A Slippery Slope*

Exhibit MB-39 Part 1

Site Plan Reference Page

This is the Preliminary Site Plan that was sent in response to the Town's request (slopes over 25% in Yellow).

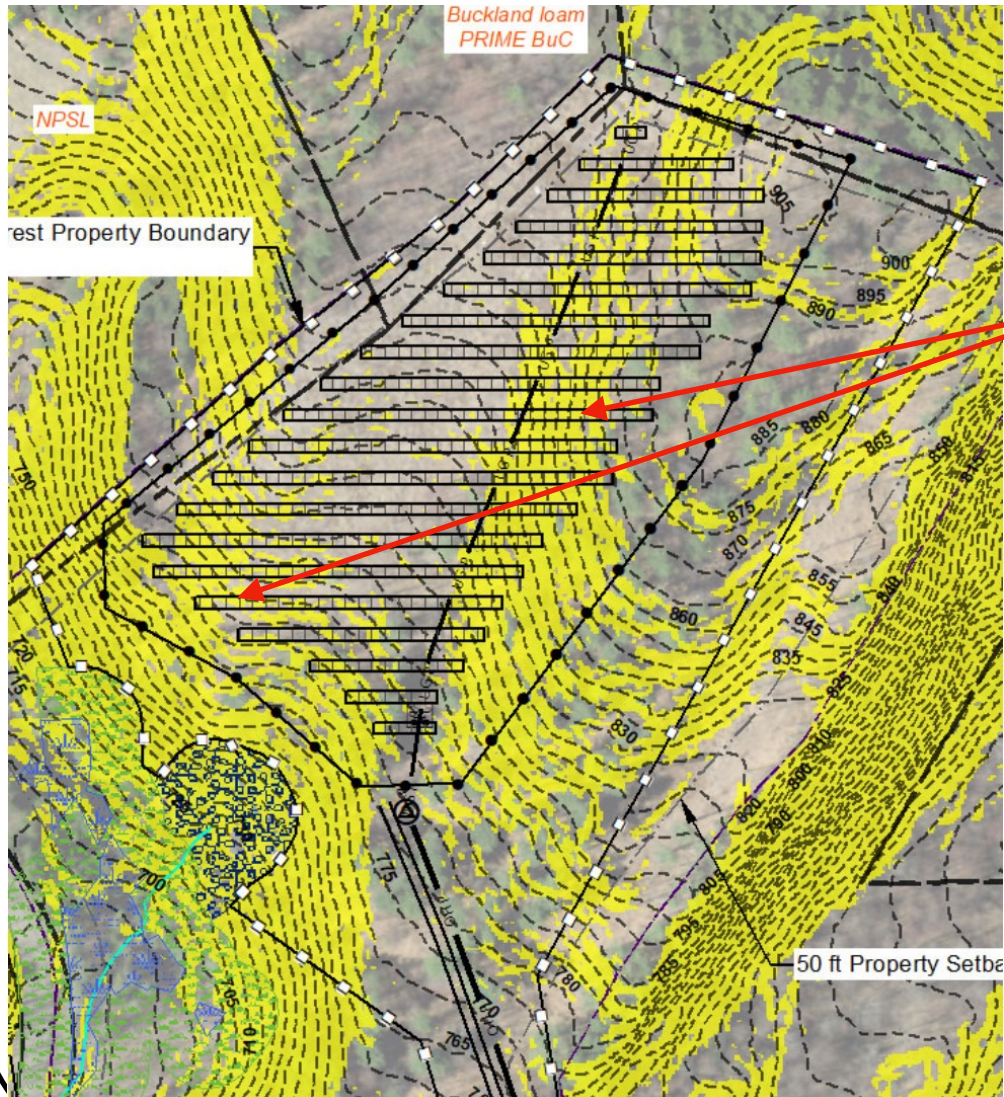
After Neighbor Intervenor alert the Town of Randolph to the slopes issue (October 2021), the Town asked the developer to overlay a 25% slope layer on the site plan.

Steep slopes under the array

👉 The Town threatened to rescind their Preferred Sites Letter unless the panels were moved off slopes greater than 25%.

In the 2nd Site Plan, the Panels are Rearranged into 2 Groups.

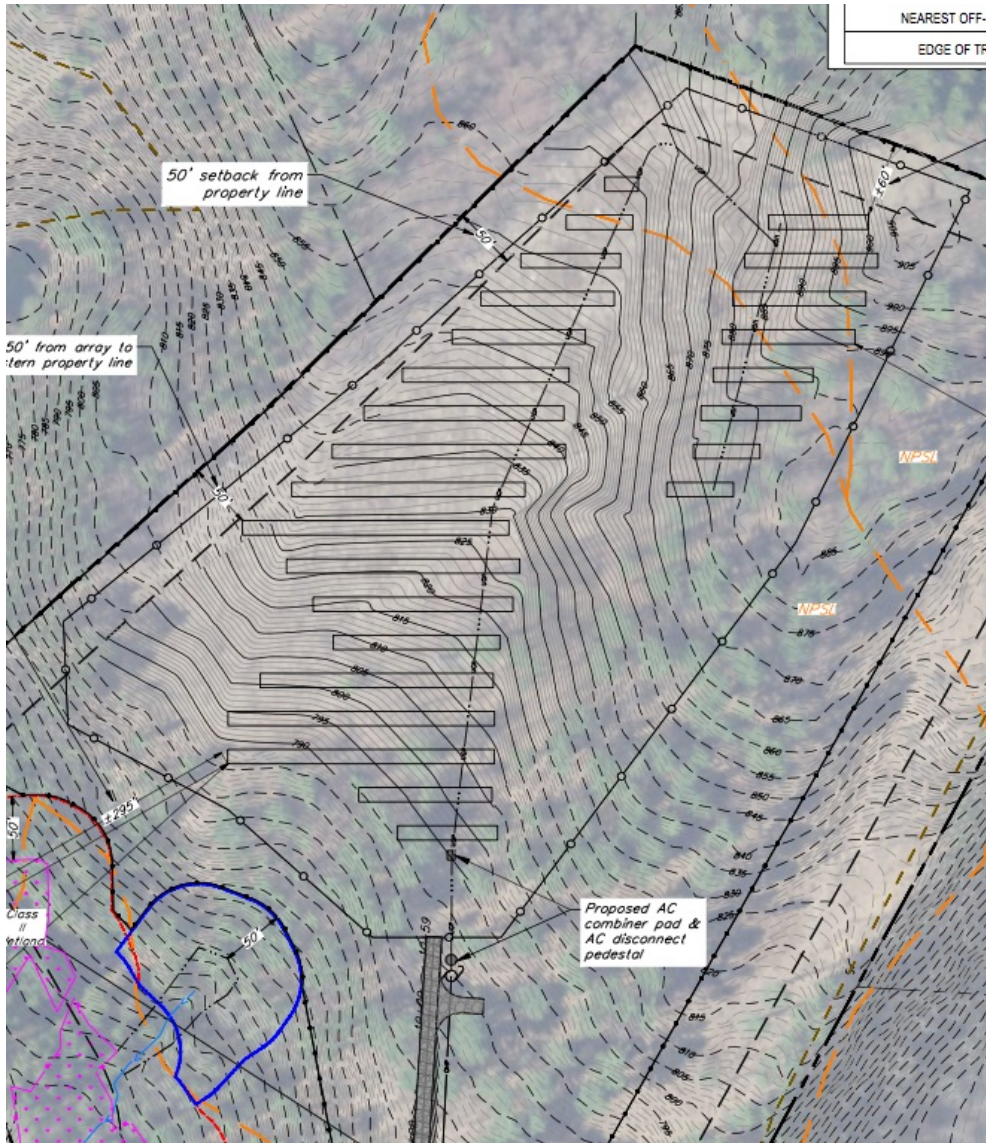
☞ The developer assured the town that, **based on a survey**, no panels were on slopes greater than 25%

Third Site Plan No Yellow Here!

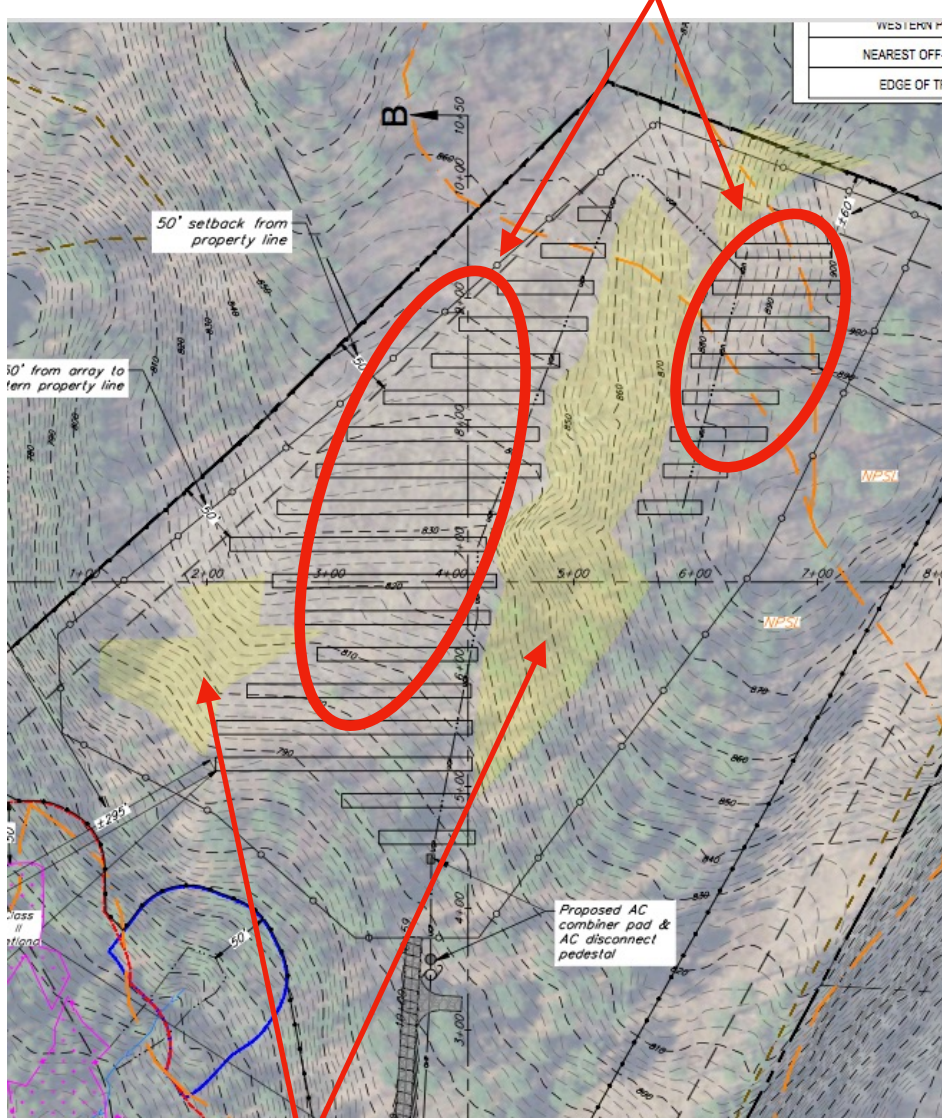
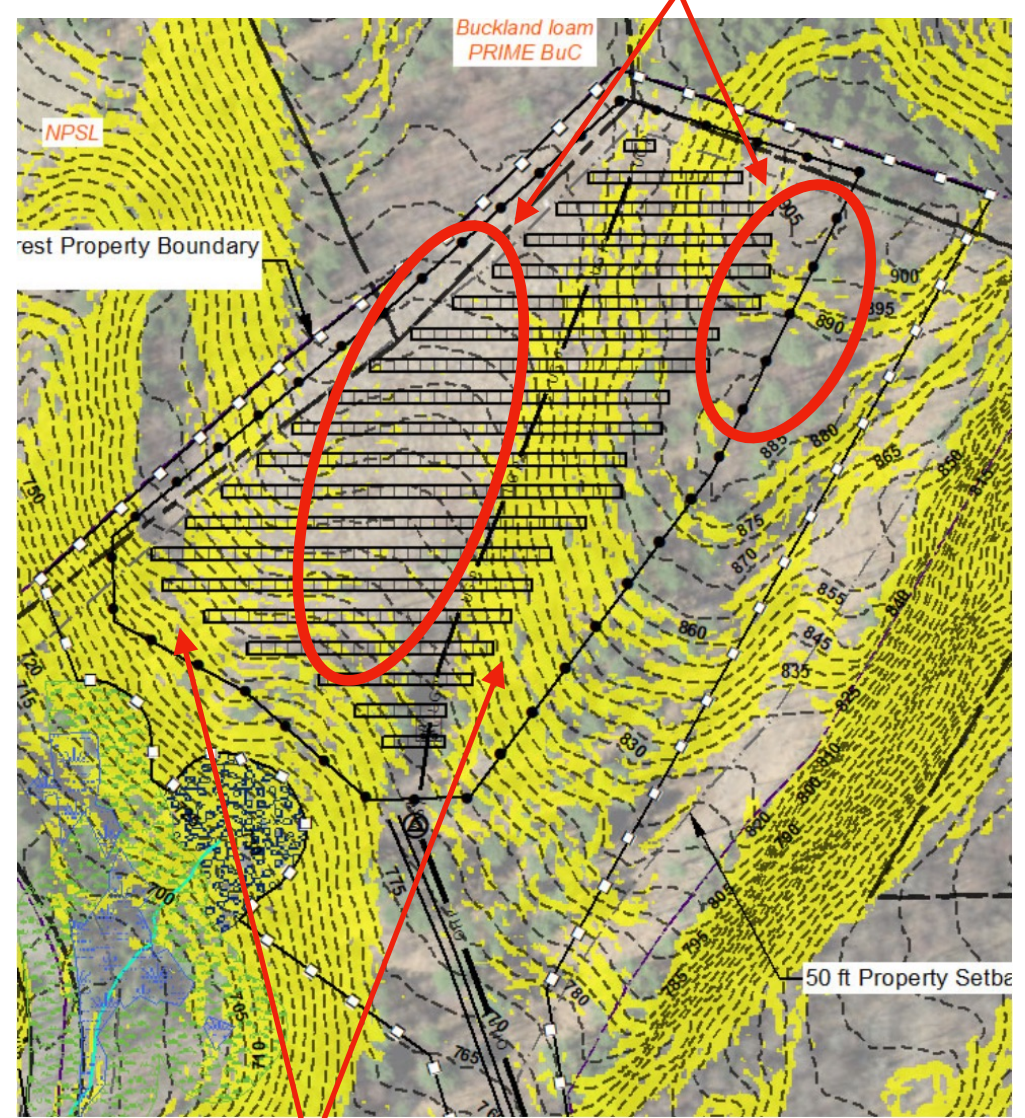
The surveyor located elevations at very few points. (see Exhibit MB-53)

When the computer determines the slope between two adjacent (but still far apart) survey points, the computer has to interpolate (guess) the elevations between the two points.

The result is that steep slopes are averaged with shallower slopes and the steep slopes just disappear from the Slope Layer.

Contrived Slope Layer with unnatural shapes and smooth edges
